**CONSTRUCTION QUALITY AUDIT OF
UNDER CONSTRUCTION CGEWHO HOUSING
PROJECT (PH-III)
KOLKATA, WEST BENGAL**

**Department of Civil Engineering
Indian Institute of Technology Roorkee
Roorkee, 247667
(April 2025)**

Figure 2: Few Instances of Anomalies in surface finishing

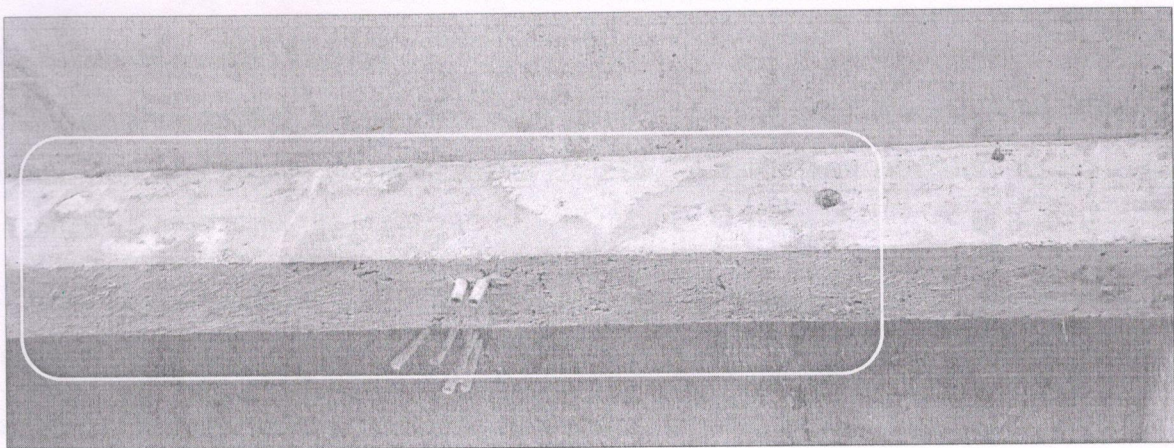
Overall, the construction quality appeared satisfactory, with no major defects observed in the completed structural elements. The surface finish was consistent, and no significant anomalies were identified across the buildings. However, minor surface irregularities were noted at a few isolated locations, which had already been rectified using cement mortar (see **Figure 2**). Additionally, isolated instances of honeycombing were observed in Block 3 (shown in **Figure 3**). Necessary instructions and advice were given at the site to avoid them.
